Limerick Generating Station, Units 1 and 2  
Facility Operating License Nos. NPF-39 and NPF-85  
NRC Docket Nos. 50-352 and 50-353

Subject: Additional Information Supporting Request for License Amendment Regarding Measurement Uncertainty Recapture Power Upate

### **RESPONSE TO REQUEST FOR ADDITIONAL INFORMATION**

Estimated capability curves  
Dwg. 369HA861 (rev 2)

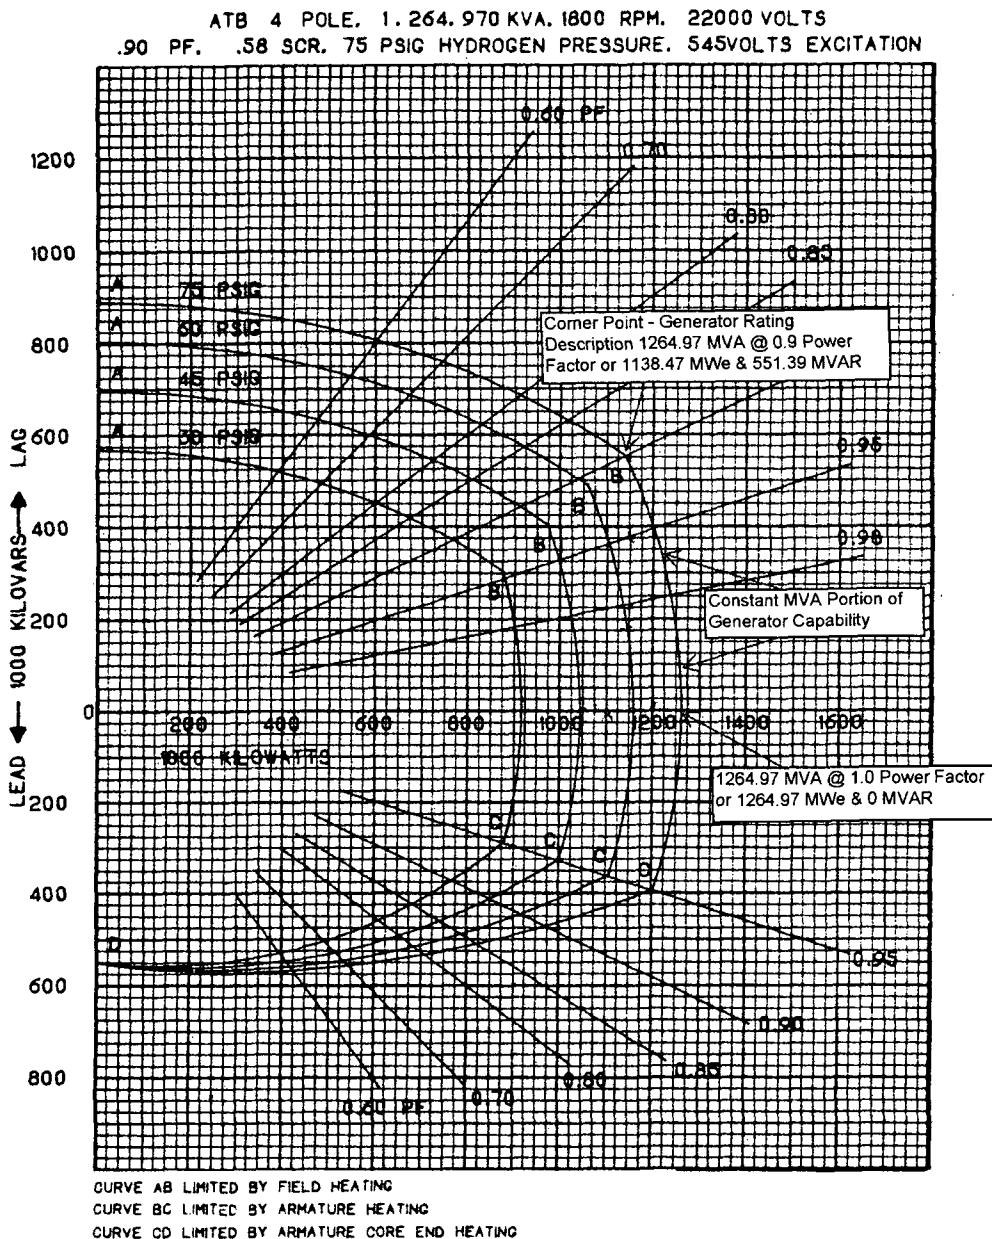
The LAR, Attachment 6, Table 6-2, shows the main generators maximum nominal rating for the uprated condition as 1138.47 MWe [Megawatts electric] and 551.39 MVar [Megavolt-amp-reactive]. The main generators maximum nominal rating of 1138.47 MWe is significantly lower than the expected full load generator output value of 1240 MWe for winter following MUR power uprate, as specified in the LAR, Attachment 12, Appendix B page 2 of 5. Please explain how the main generators worst case (winter) expected MWe output can exceed the maximum nominal MWe rating.

LAR Table 6-2 shows the generator nominal rating of 1264.97 MVA at 0.9 power factor and 75 psig hydrogen pressure. The 1264.97 MVA at 0.9 power factor can also be stated as 1138.47 MWe and 551.39 MVAR. This rating refers to a single point on the generator capability curve where the stator and armature capacity are the same at a lagging power factor. This point is also referred to as a corner point. The corner point is shown on the attached generator capability curve for Limerick. For values of power factors between 0.9 lagging (Point B on the curve) and 0.95 leading (Point C on the curve) the generator capability curve is a constant MVA curve. The generator can operate on or below this constant MVA curve. For Limerick the constant MVA curve is 1264.97 MVA. As a result, at 1.0 power factor the generator can produce 1264.97 MWe and 0 MVAR. At all the points on the constant MVA portion of the curve the vector sum of the MWe and MVAR are equal to 1264.97 MVA. The generator can operate on or below the capability curve but not above it. Therefore, the winter loading of 1240 MWe is associated with an MVAR limit of no more than 250.1 MVAR or a total of 1264.97 MVA. The MWE and MVAR loading are controlled at or below this curve as requested by the transmission system operator.
